September 23, 2022

Subject: Bishop Creek Hydroelectric Project (FERC Project No. 1394-080)

- 1. Response to Additional Information Requests**
- 2. Updates on Supplemental Reports.**

Figure 3.2-2. Lake Sabrina Storage and Area Curves

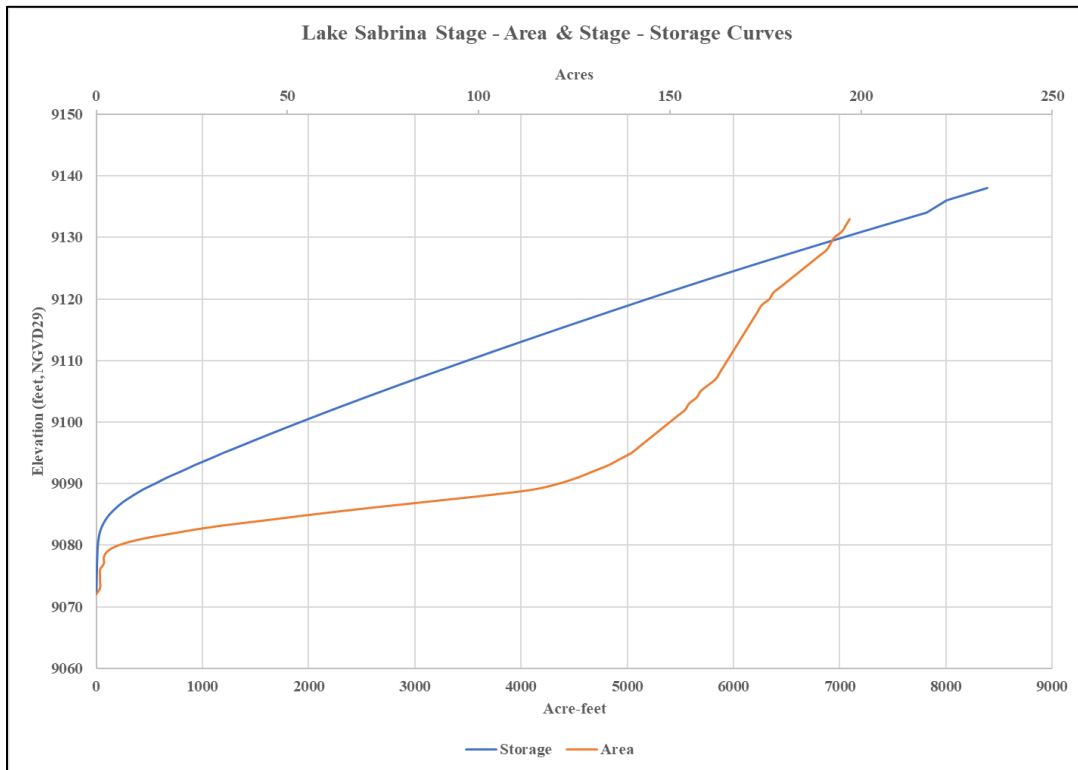
Item 1 sought identified discrepancies between Exhibits A and B in the reported surface area of Lake Sabrina. These have now been made consistent.

Item 2 noted inconsistencies in storage values associated with Lake Sabrina throughout the FLA and asked SCE to clarify relationship between gross and net storage at all reservoirs. These clarifications have been made as reflected in the revised Exhibits A, B, and E.

Figure 9.8-1. Bishop Creek Wolverine Habitat Range

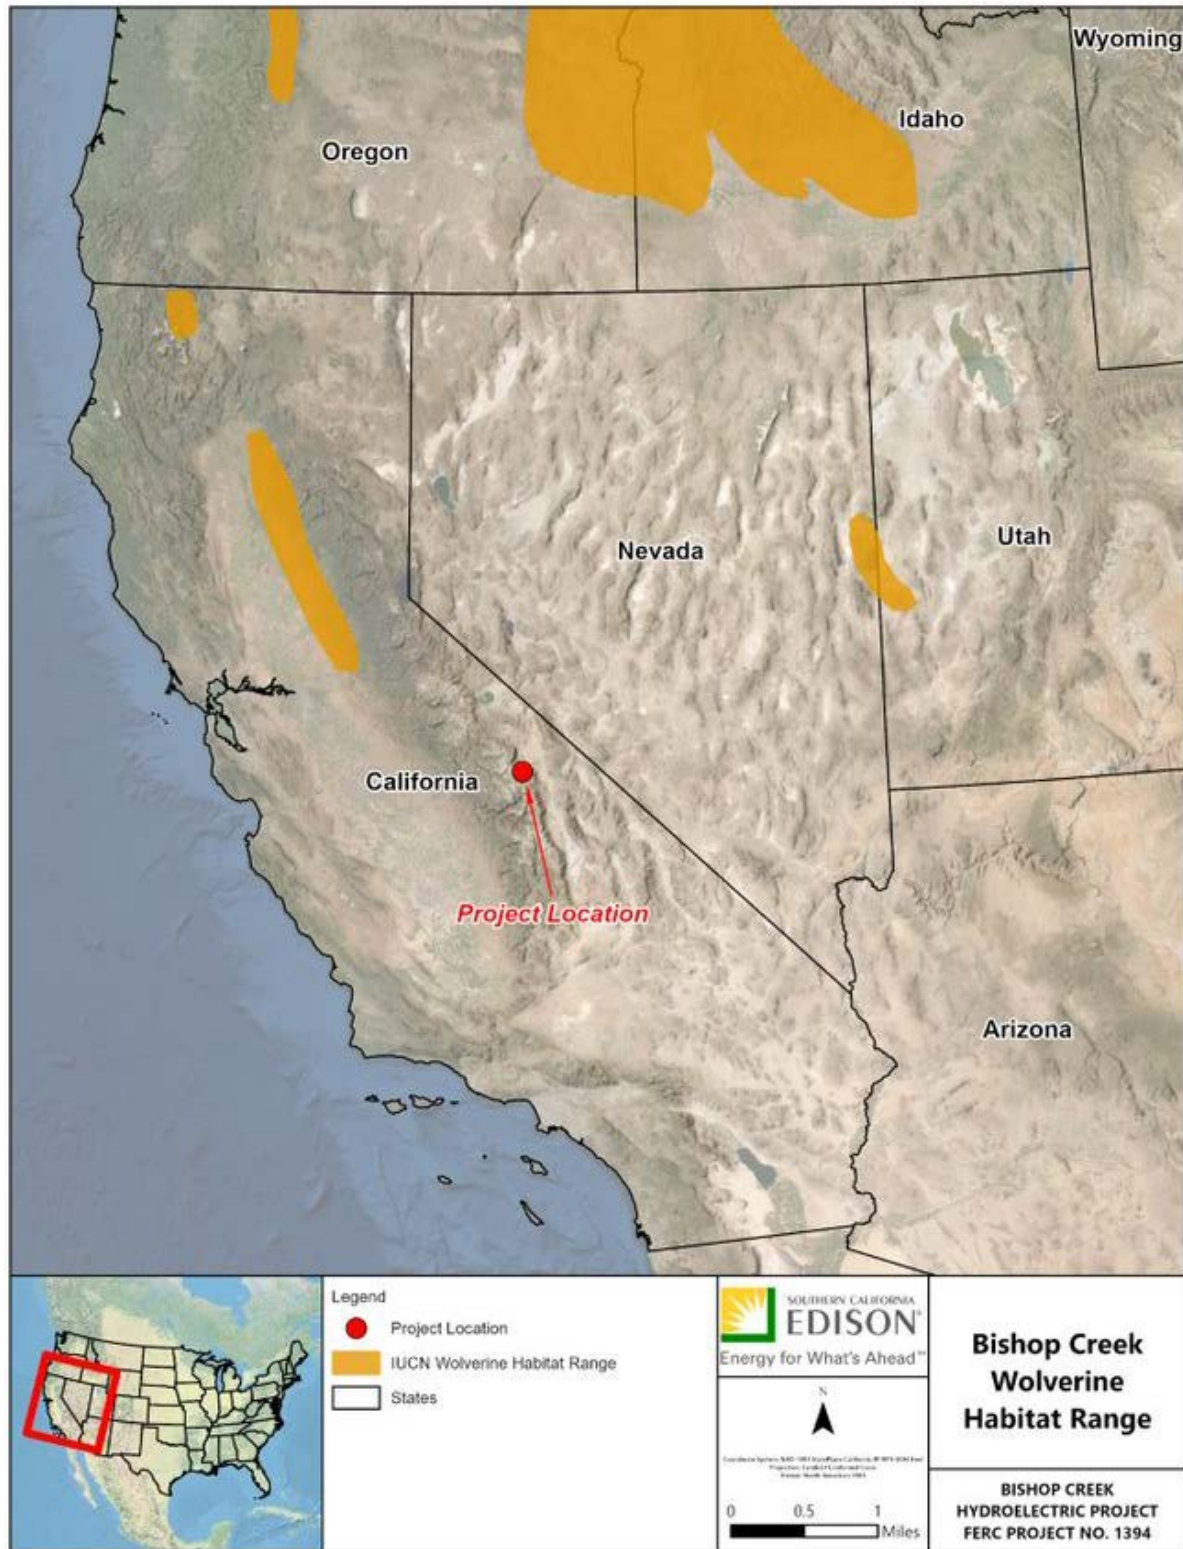
Item 3 requested that SCE provide additional information on fish slough milk vetch (threatened) and North American wolverine (proposed threatened) which were identified U.S. Fish and Wildlife Service's Information, Planning and Conservation database on July 25, 2022, as having the potential to occur in the Project Area. SCE's previously submitted FLA discussed these species and concluded that they are not likely to occur in the Project area, and were not likely to be affected by project

operations. SCE has provided additional information on these species life history and has included additional maps, as requested. This information can be found in the revised Exhibit E, in Section 9.8.7.
